**CAMECO RESOURCES
CROW BUTTE OPERATION**

Annual Report of Changes, Tests, or Experiments
License No. SUA-1534
Docket No. 40-8943

**Crow Butte Resources, Inc.****Safety and Environmental Review Panel****Evaluation Report – SERP #17-01****Figures 1, 2, and 5 in the Evaporation Pond Onsite Inspection Program****Approved December, 1992****Revised February, 1996****March 16, 2017**

Figure 5.1-1: Crow Butte Resources Organizational Chart

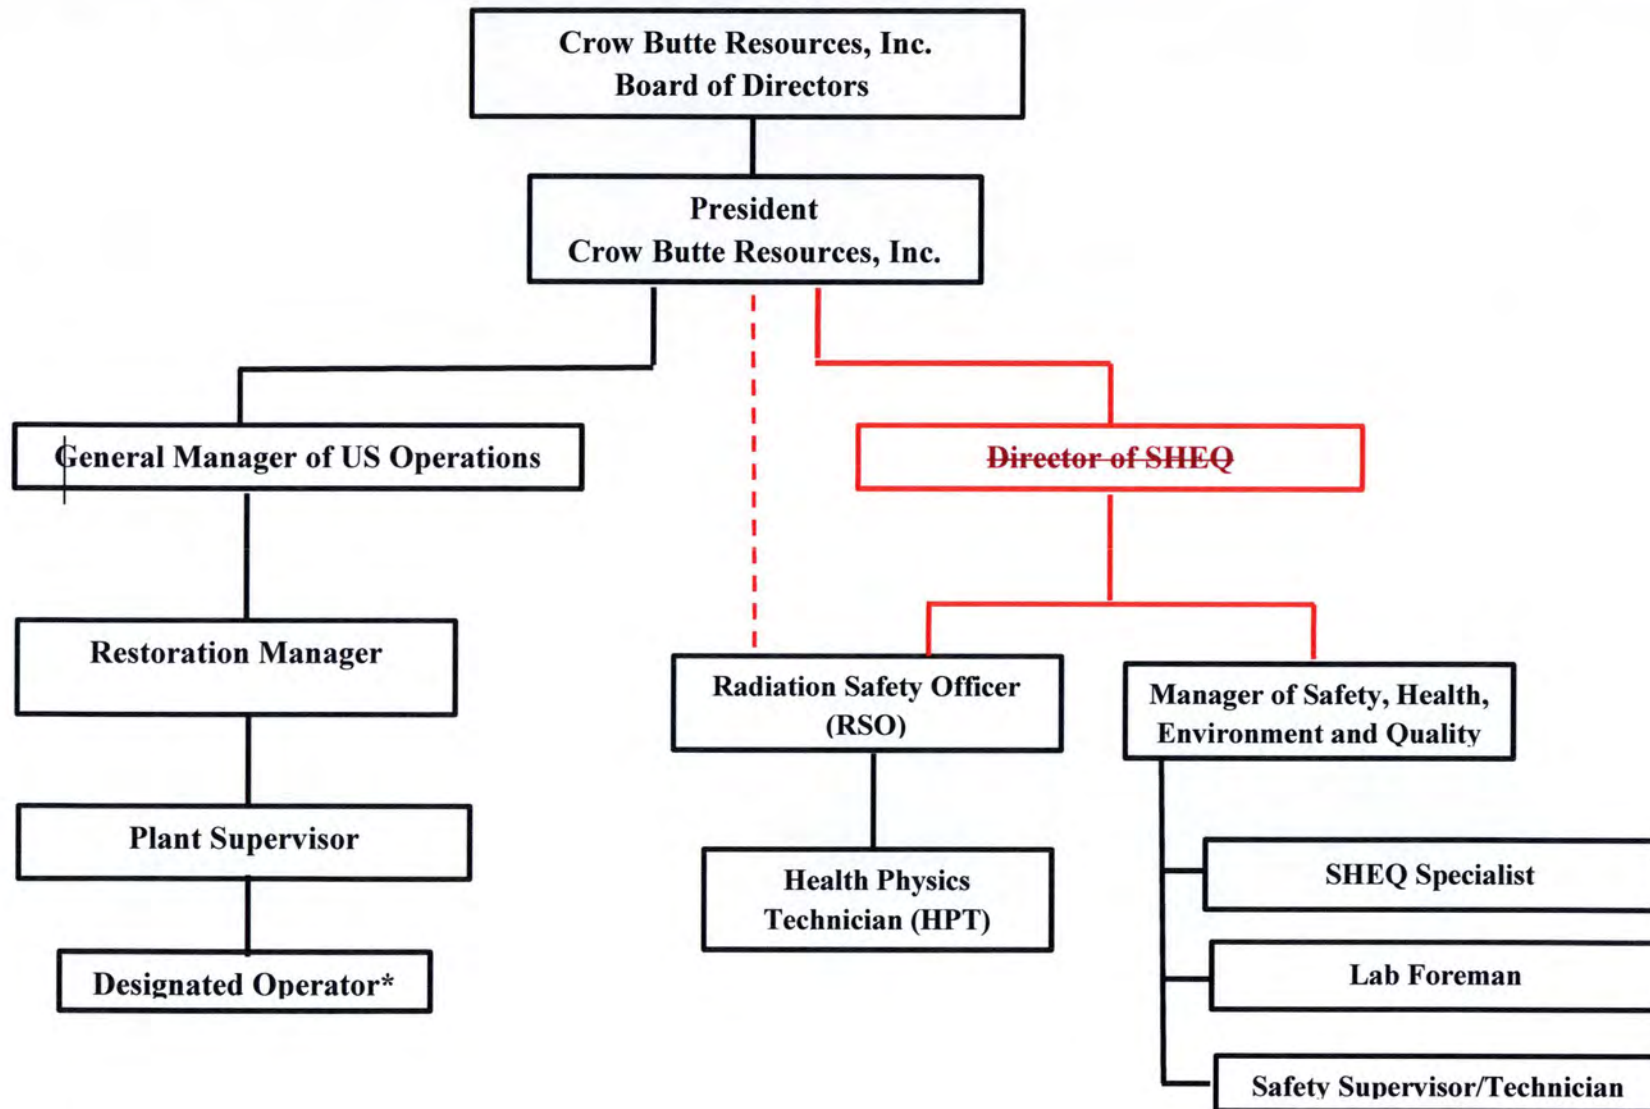
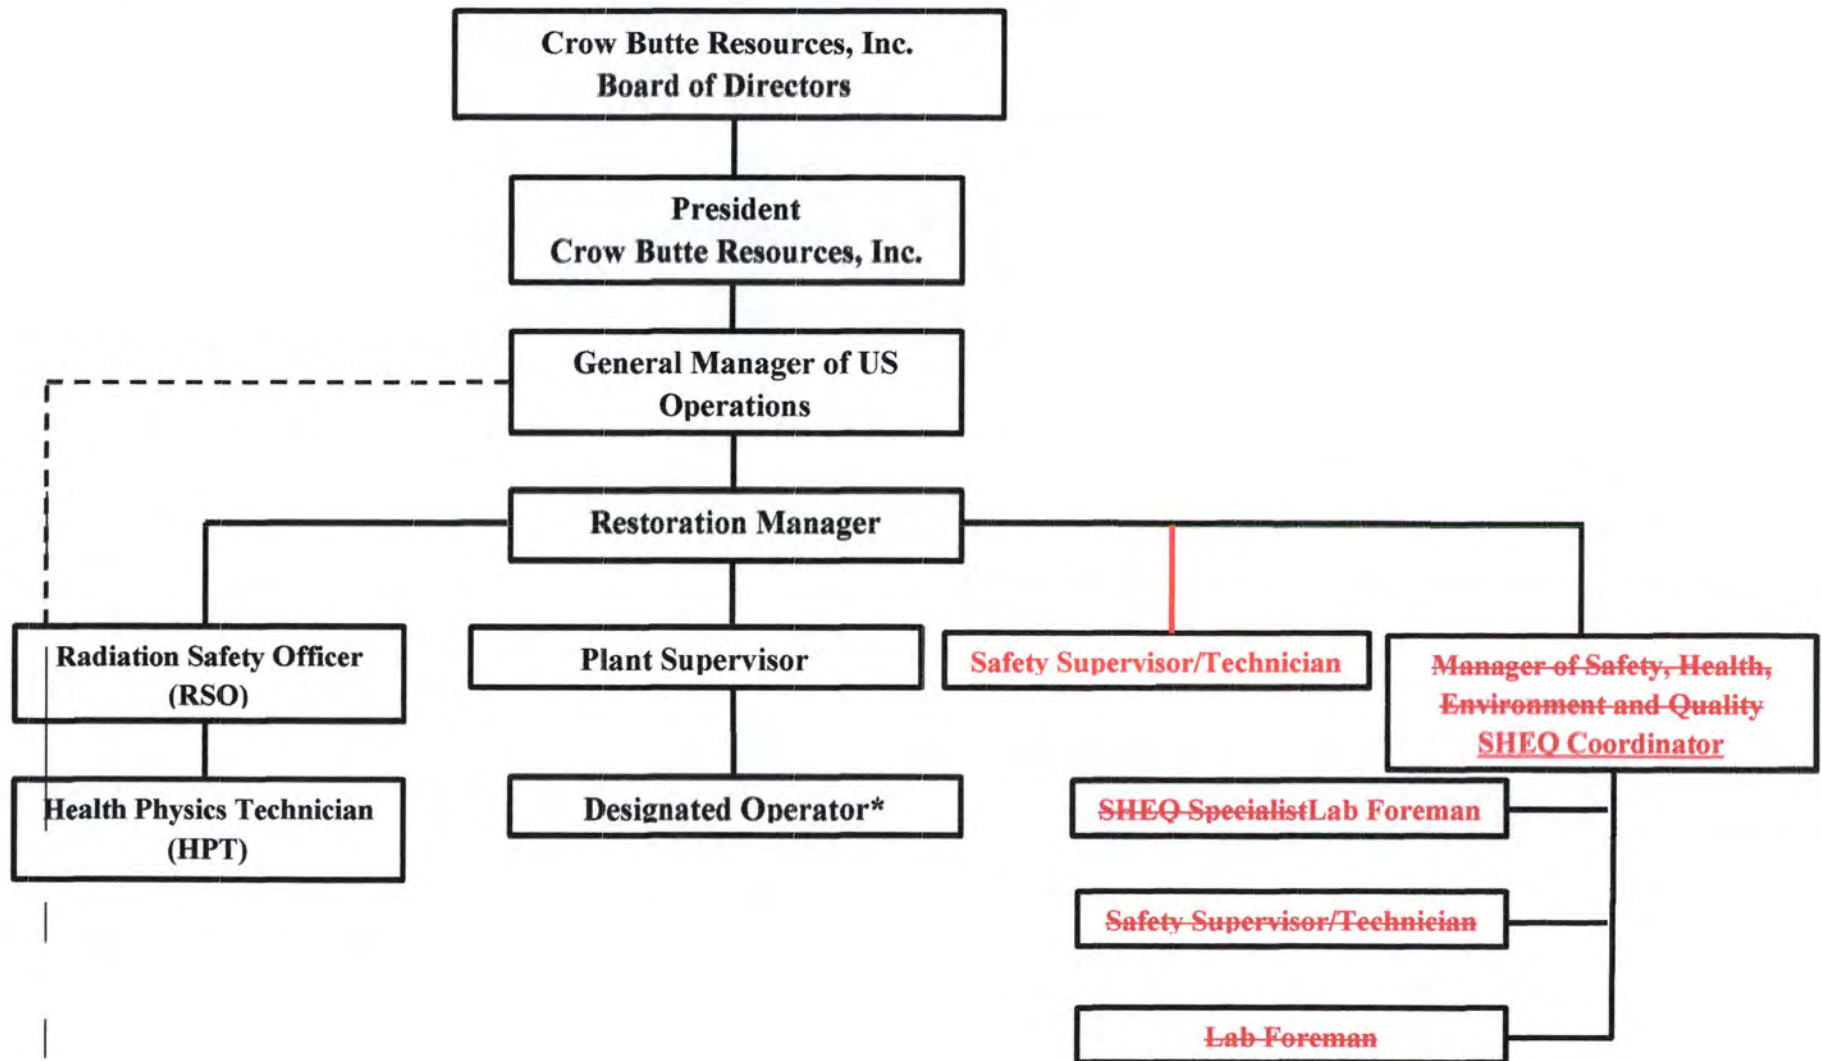
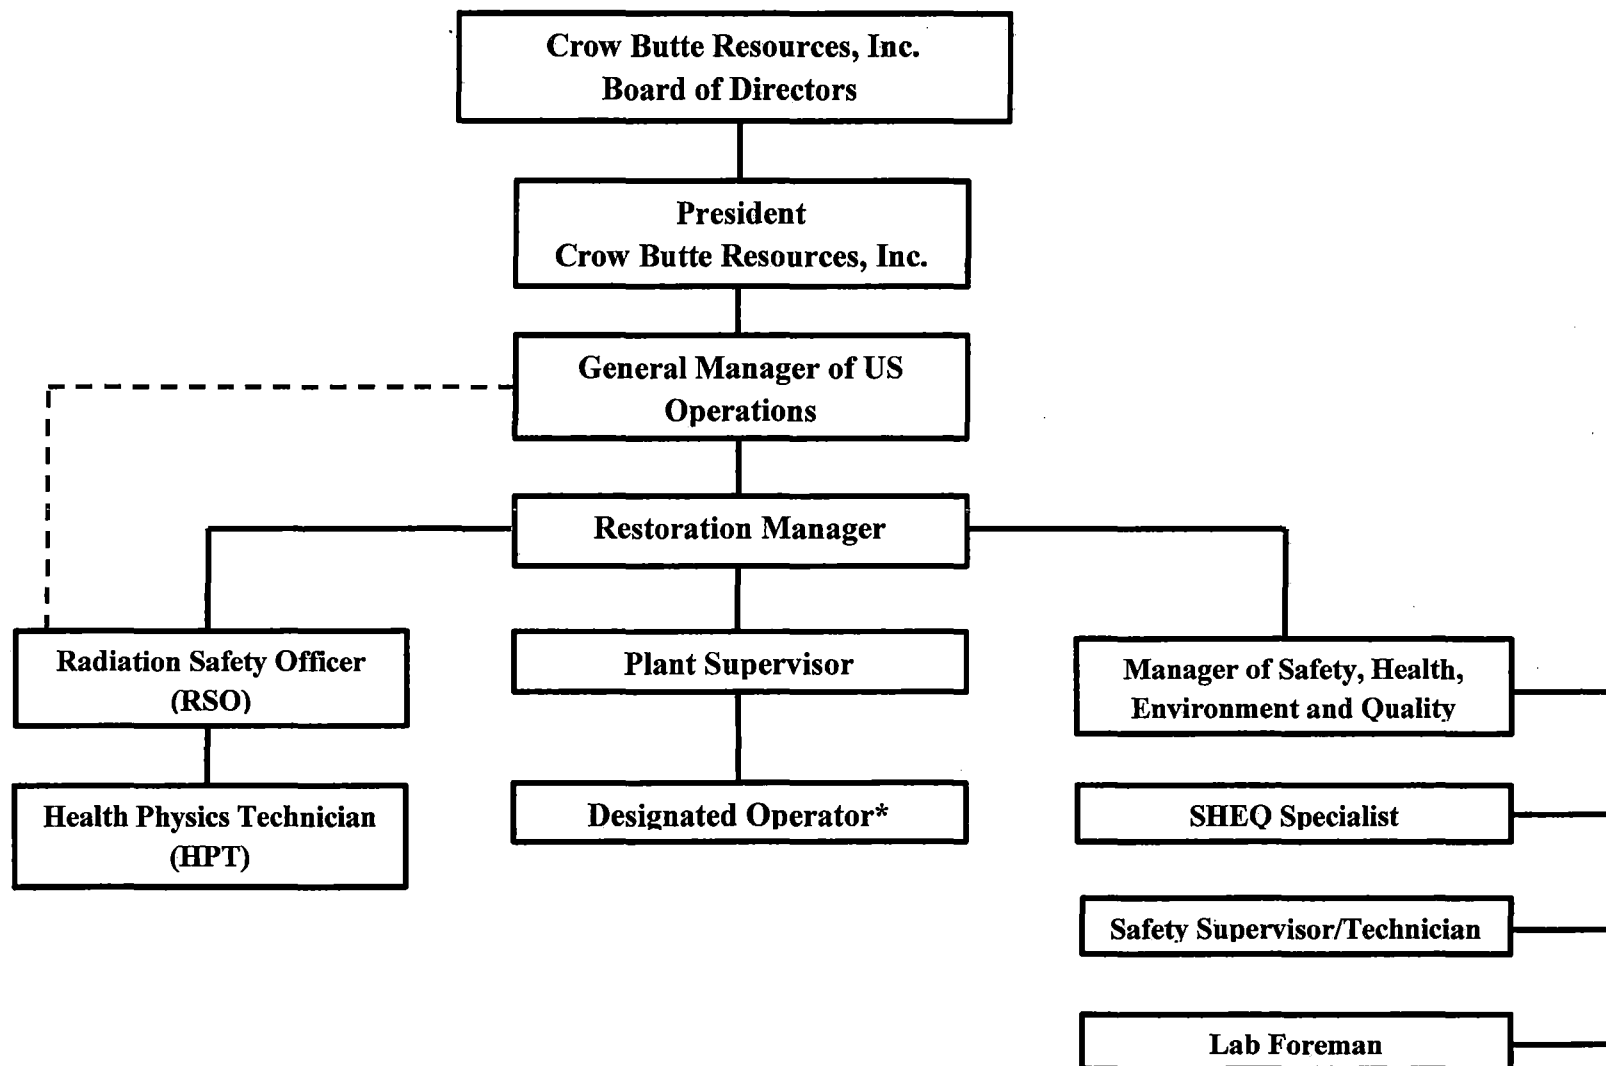
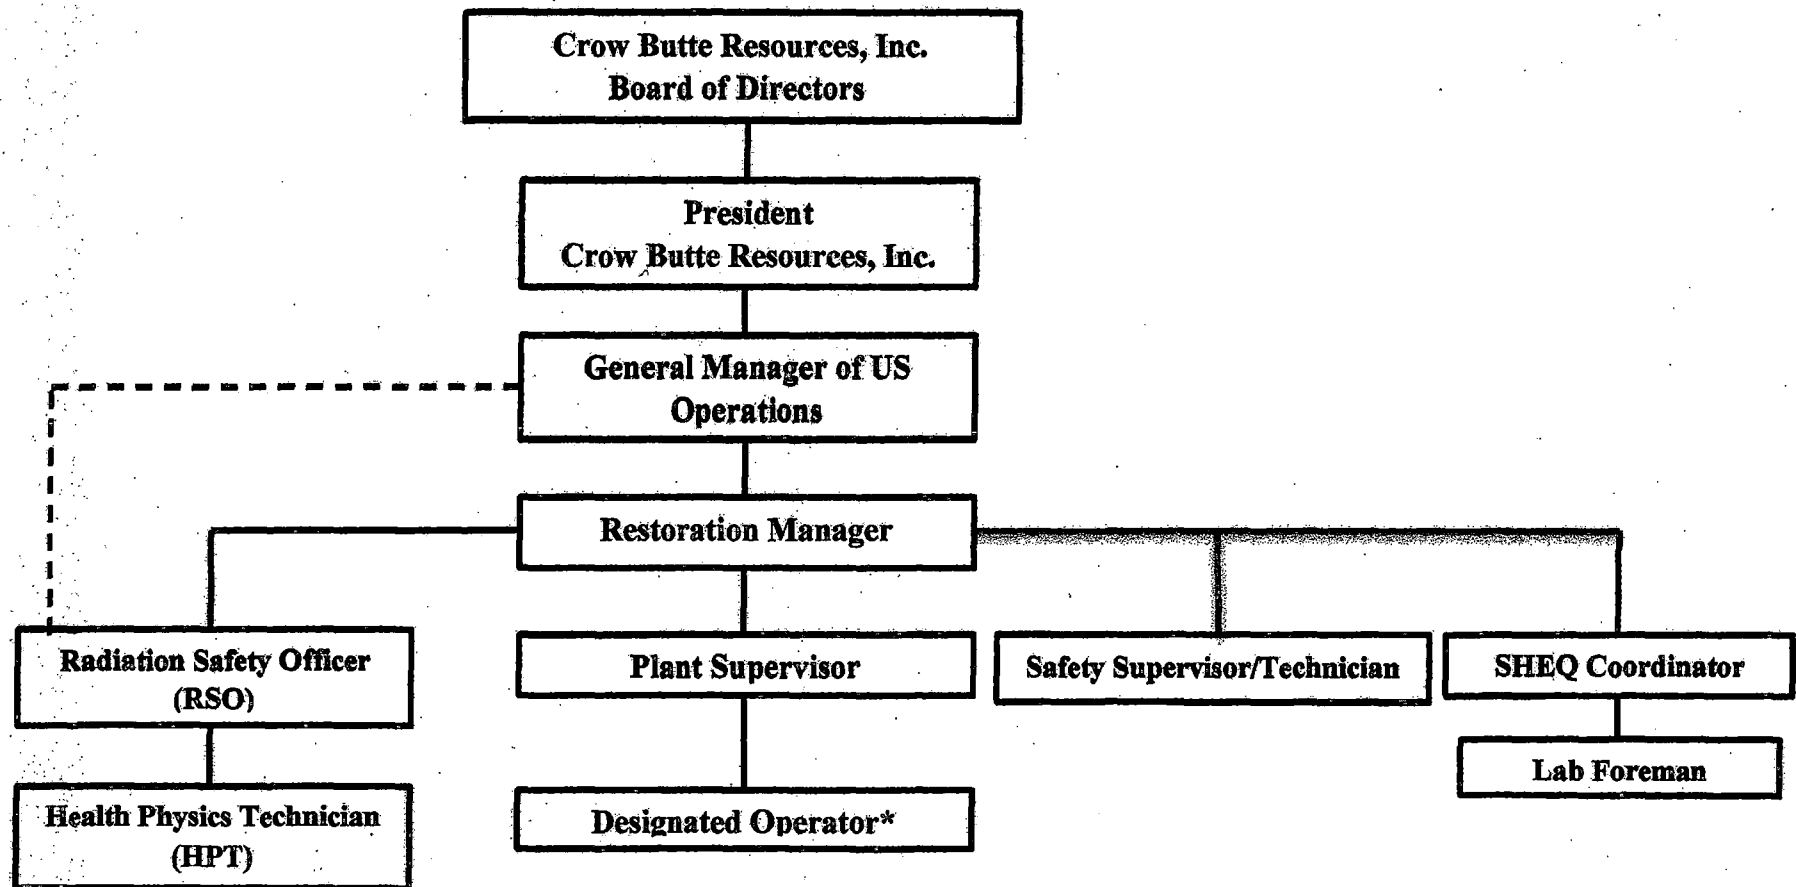
The purpose of the SERP evaluation was to review a change made to the Cameco Divisional organizational structure. This evaluation removes the position of Director of Safety, Health, Environment, and Quality (SHEQ). These change affects the direct and indirect reporting requirements for the Radiation Safety Officer.

An organizational change was made that directly and indirectly affected the reporting responsibilities of the radiation safety staff. The direct reporting of the Radiation Safety Officer (RSO) has been changed as shown in the revised Figure 5.1-1 from the approved License Renewal (November 2014). The RSO currently reported to the Director of SHEQ, with the organizational change, the RSO now reports directly to the Restoration Manager. The indirect reporting for the RSO has been changed as shown in the revised Figure 5.1-1 from the approved License Renewal (November 2014). The RSO currently reports indirectly to the President. With the organizational change, the RSO will have an indirect reporting requirement to the General Manager of U.S. Operations.
